SUBDIVISION REVIEW SHEET

<u>CASE NO.</u>: C8-2016-0105.0A <u>PC DATE</u>: 6/14/16

SUBDIVISION NAME: Rosewood Village Sect. 5 Resubdivision of lot 4

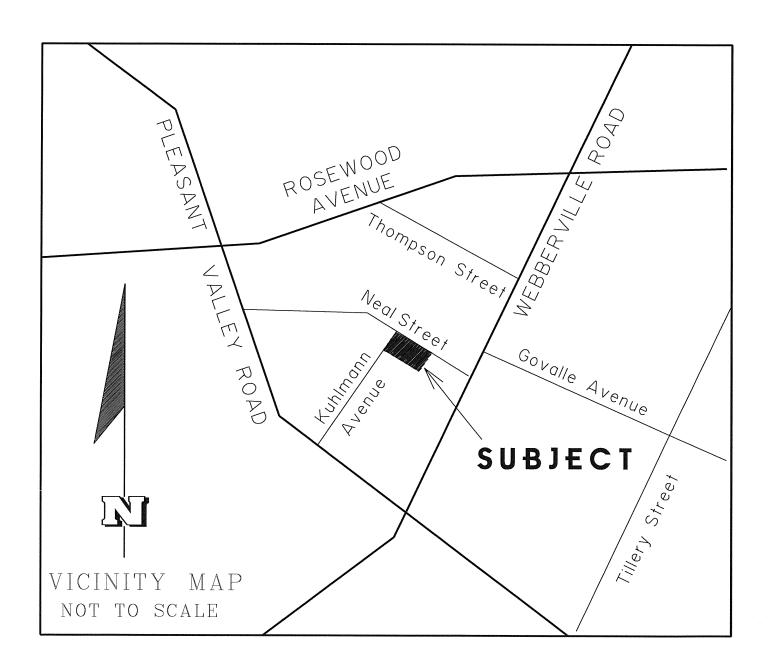
<u>DEPARTMENT COMMENTS</u>: The request is for the approval of Rosewood Village Sect. 5 Resubdivision of lot 4. The proposed plat is composed of 2 lots on .30 acres.

STAFF RECOMMENDATION: The staff recommends disapproval of the plat. This plat does not meet all applicable State and City of Austin LDC requirements.
